Our reference: D220002

**D220002: Minister of Education Notice of Requirement Rolleston Secondary School:
Request for further information**

Andy Carr from Carriageway Consulting has been engaged by the Council to undertake a peer review of the ITA. Mr Carr has provided the following comments and requested for further information:

Figure 2: South East site and surrounding environment. Source: Canterbury Maps

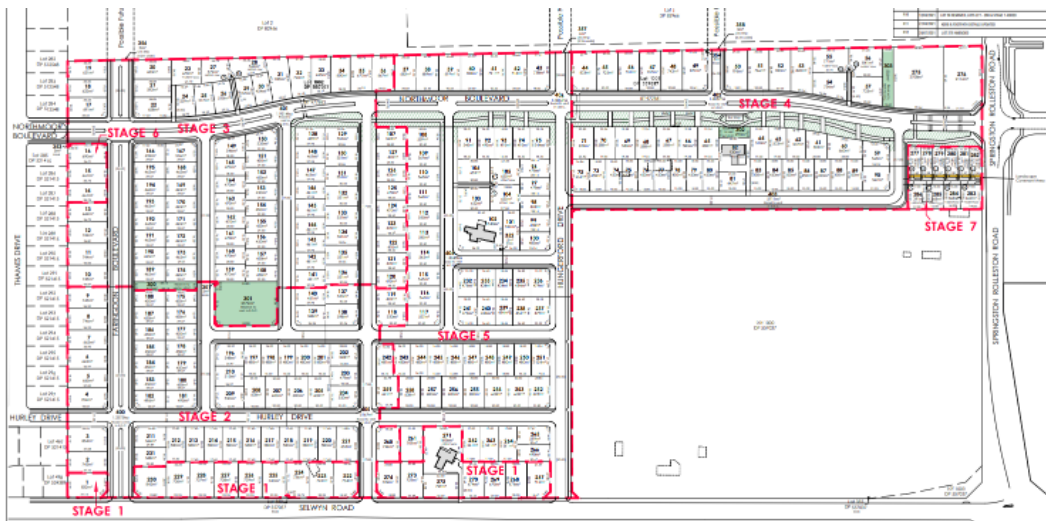
Para 2.1: The ITA notes that the site "*is located in the Faringdon South-East subdivision*". However the application to the EPA shows that this area was not included, as shown below.

It is also not within the site boundaries of the approved EPA plan of the area:

Please clarify this comment in the ITA.
